Date: 21st May 2021
Our Ref: R18/1004/Reg25/Add3/DRK

**Ref: Noise & Vibration Impact Assessment for Proposed Sand & Gravel Quarry
Land at Bow Farm, Bow Lane, Twyning, Tewkesbury, Gloucestershire
Application Number: 19/0081/TWMAJM (District Ref: 19/1231/CM)**

NOISE MAP 5: EXTRACTION ACTIVITIES PHASES 1 & 2 (WITH PROCESSING)

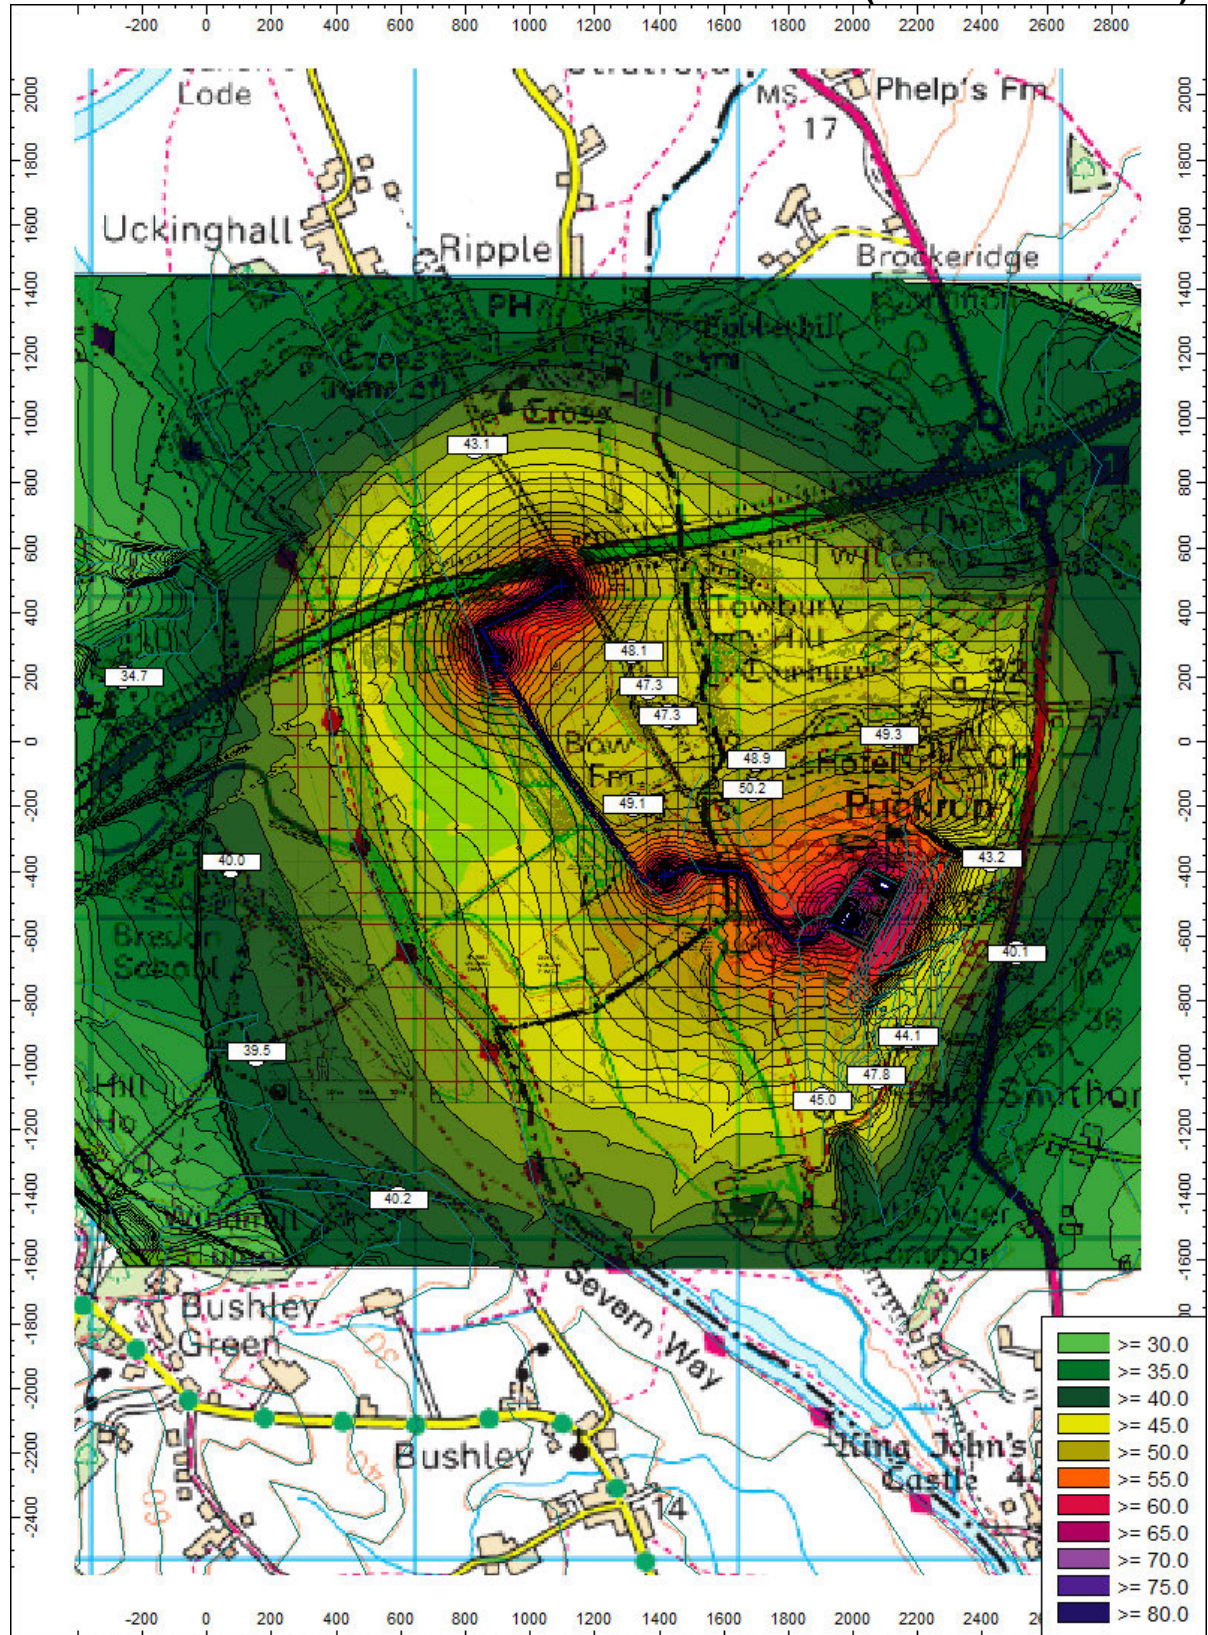
Ardent make the comment that there is a higher-level during extraction than during earth mound works, there is a reason for this, which I explain below:

Table 6.3 refers to Phases 1 & 2 with screening. The levels here did actually include the effect of the processing plant rather than just the extraction noise source and so were artificially higher than they should read. I have provided below Table 6.3 which **excludes** the processing plant and levels at Puckrup Hall drop from 39-49 to 39dB LAeq. This can be seen in the noise mapping in Appendix NVC/9 when comparing noise map 5 (which includes the processing plant) and noise map 6 which does not (also attached for ease of reference).
